HISTORIC AND DESIGN REVIEW COMMISSION

December 05, 2018

HDRC CASE NO: 2018-557
ADDRESS: 1107 N PINE ST
LEGAL DESCRIPTION: NCB 515 BLK 17 LOT 2
ZONING: R-6, H
CITY COUNCIL DIST.: 2
DISTRICT: Dignowity Hill Historic District
APPLICANT: Monica Cardenas/Business World Contractors
OWNER: Ronald Sanchez
TYPE OF WORK: Construction of a rear addition
APPLICATION RECEIVED: October 29, 2018
60-DAY REVIEW: December 28, 2018
REQUEST:

The applicant is requesting a Certificate of Appropriateness for approval to construct a rear addition to feature 156 square feet in size.

Site 1/8" = 1'-0"

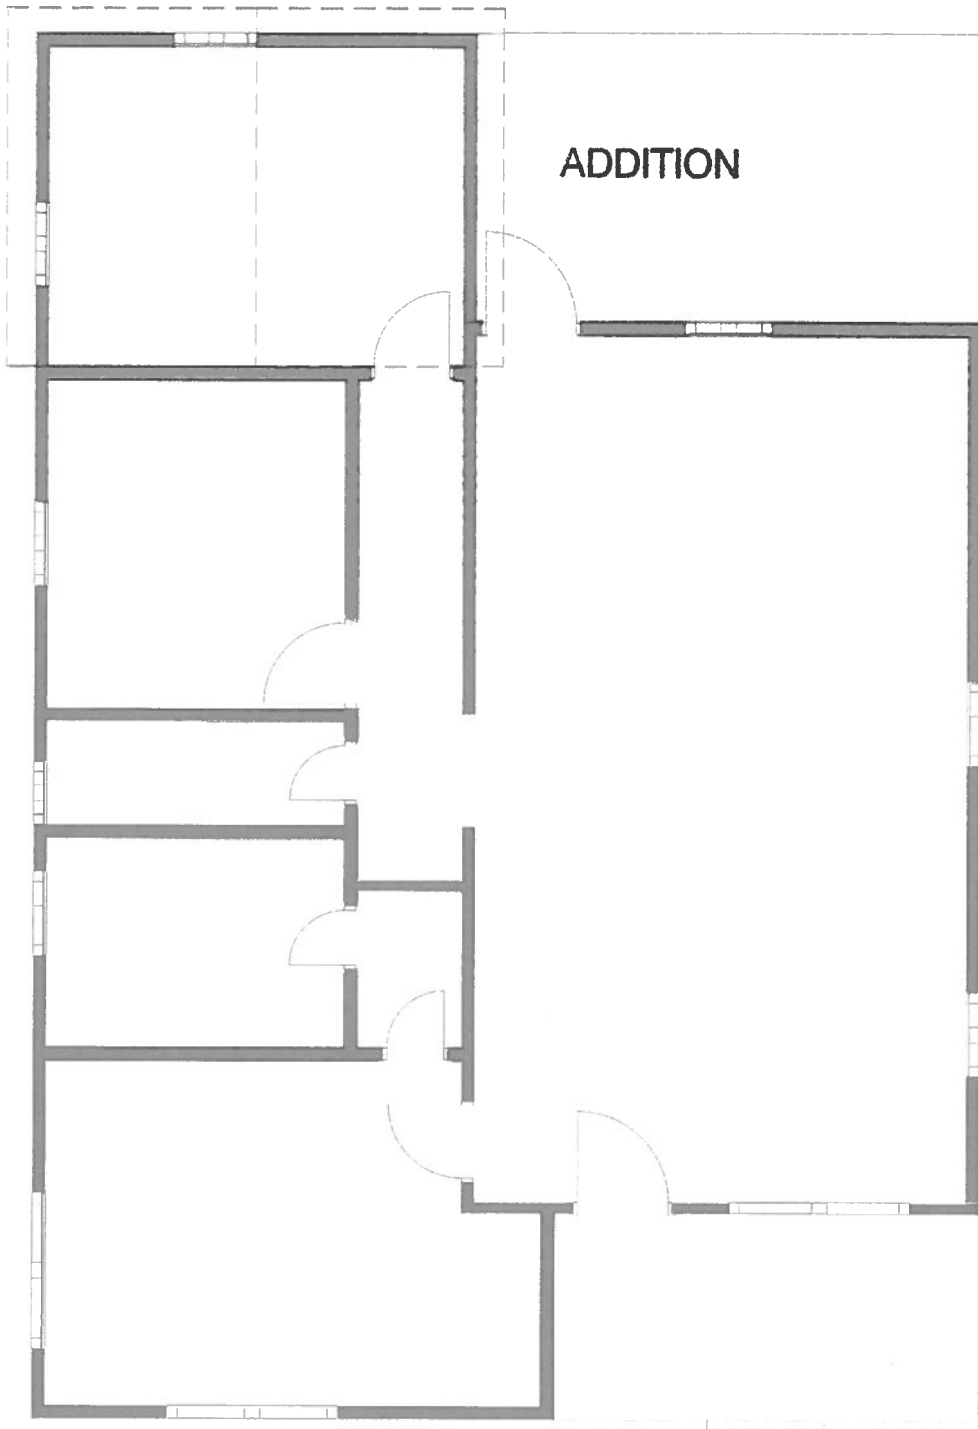
- c. REAR ADDITION – The Guidelines for Additions 1.A. states that additions should be sited to minimize visual impact from the public right of way, should be designed to be in keeping with the historic context of the block, should utilize a similar roof form and should feature a transition between the old and the new. Per the submitted site plan, the applicant has proposed for the rear addition to feature a subordinate roof form and an inset on one façade from the wall plane of the historic structure. This is consistent with the Guidelines.

- d. ROOF FORM – As noted in finding c, the applicant has proposed for the addition to feature a rear facing gabled roof, comparable to that of the primary structure. This is consistent with the Guidelines.

Staff recommends approval based on findings a through f with the following stipulations:

South Elevation

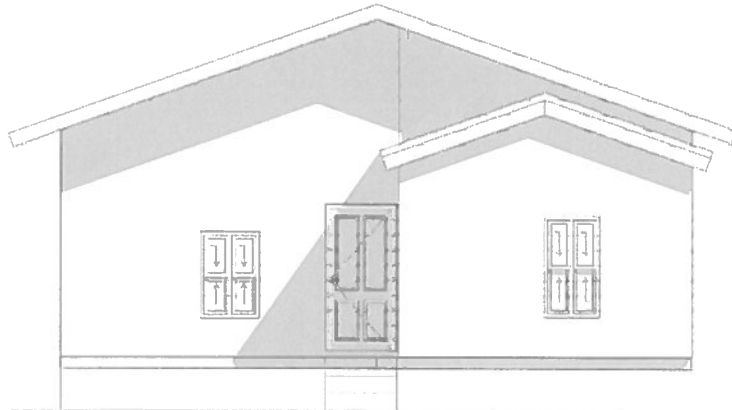
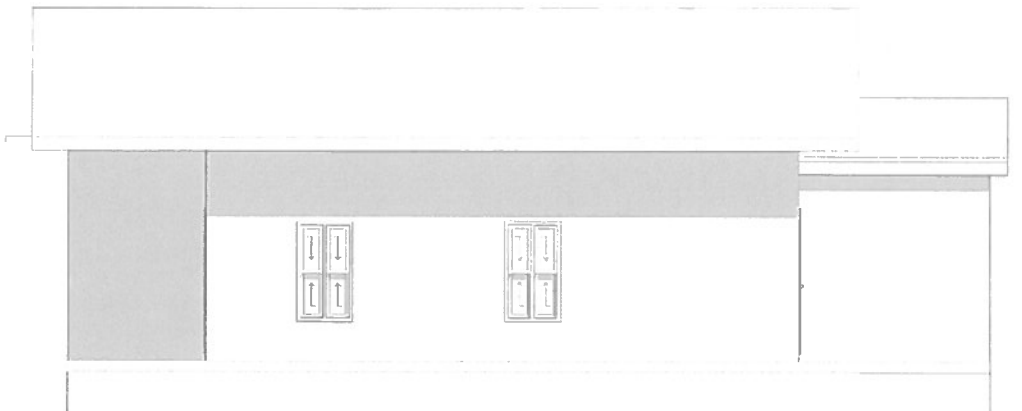
- e. MATERIALS – The historic structure features a composite siding that currently covers the original siding. The applicant has proposed for the addition to feature smooth faced composite siding. Staff finds that composite siding that features a profile that matches or is less than that which currently exists should be used.

- a. WINDOW MATERIALS – The applicant has noted that wood or aluminum clad wood windows will be installed. The following specifications should be followed: That the windows feature meeting rails that are no taller than 1.25” and stiles no wider than 2.25”. White manufacturer’s color is not allowed, and color selection must be presented to staff. There should be a minimum of two inches in depth between the front face of the window trim and the front face of the top window sash. This must be accomplished by recessing the window sufficiently within the opening or with the installation of additional window trim to add thickness. Window trim must feature traditional dimensions and an architecturally appropriate sill detail. Window track components must be painted to

- f. ARCHITECTURAL DETAILS – Generally, staff finds the proposed massing and form of the proposed addition to be appropriate.

- i. That the addition's roofing material match that of the primary historic structure.
- ii. That the addition's siding feature a profile that either matches or is less than the profile of the primary structure's composite siding.

- iii. That the wood or aluminum clad wood windows feature meeting rails that are no taller than 1.25" and stiles no wider than 2.25". White manufacturer's color is not allowed, and color selection must be presented to staff. There should be a minimum of two inches in depth between the front face of the window trim and the front face of the top window sash. This must be accomplished by recessing the window sufficiently within the opening or with the installation of additional window trim to add thickness. Window trim must feature traditional dimensions and an architecturally appropriate sill detail. Window track components must be painted to match the window trim or concealed by a wood window screen set within the opening.
